SUBDIVISION COMMITTEE
METROPOLITAN AREA PLANNING COMMISSION

STAFF REPORT

(Final Plat, Preliminary Plat Approved 1/23/92)

CASE NUMBER: S/D 92-2 - CORDEL FARMS ADDITION

VICINITY MAP:

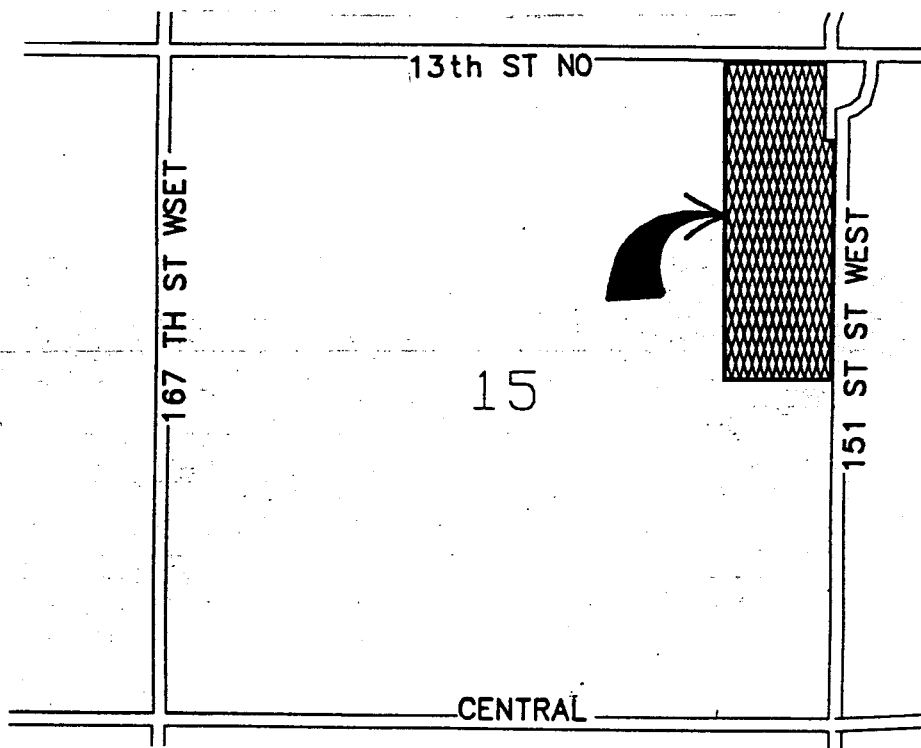
NOTE: This site is located in the County at 151st St. West. Although 151st St. West is a mile line arterial, approximately 750 feet south of 13th St. North, this street jogs eastward off of the section line. The southern three lots (lots 4, 5, and 6) do therefore have indirect access to 13th St. N. by way of 151st St. West. As can be noted on the plat significant portions of the site are encumbered by floodway which is apparently forcing somewhat irregular lot configurations and makes the creation of an interior or local through street impractical. STAFF COMMENTS:

- A. Since neither municipal water nor sanitary sewer is available to serve this property, the applicant shall contact the Environmental Health Division of the Health Department to find out what tests may be necessary and what standards are to be met for approval of on-site sewerage facilities and water wells. A memorandum shall be obtained specifying approval.
- B. On the final plat tracing, the plattor's text shall be corrected to indicate that access controls to 151st St. West include the controls shown for Lot 3, and not access from Lot 1.
- C. The applicant shall provide proof, by letter or by copy of the pipeline easement agreements, that the pipeline easements as shown are sufficient and that utilities may be located adjacent to and within the easements. Any relocation, lowering or encasement of the pipeline, required by this development, will not be at the expense of the County.

For the pipeline running along the east line of this plat, the indicated building setback is apparently from that pipeline. However, in order to assure that a setback would still be recognized in the event the pipeline was to relocate or alter its setback requirements, the setback along the east line of the plat should be labeled "Platted and Pipeline Building Setback."

- D. On the final plat the names of the pipeline companies holding the easements shall be indicated along with the recording information for the easements.
- E. As requested by County Engineering, the applicant shall submit a covenant concerning the County's authority to maintain the floodways and if need be to charge back any costs to the involved property owners, in a manner similar to special assessments.

- F. Approval of this plat will require a waiver of the lot depth to width ratio of the Subdivision Regulations. The Subdivision Regulations state that, "the maximum depth of all residential lots shall not exceed 2-1/2 times the width thereof." The proposed lot depths range from 3.25 times to 4.7 times the width.

- L. The representative from the County Engineer's office should be prepared to comment on the status of the applicant's drainage plan. Specifically, is the minimum building pad correct, are the boundaries of the floodway adequate and are any drainage guarantees required with the platting of this property?
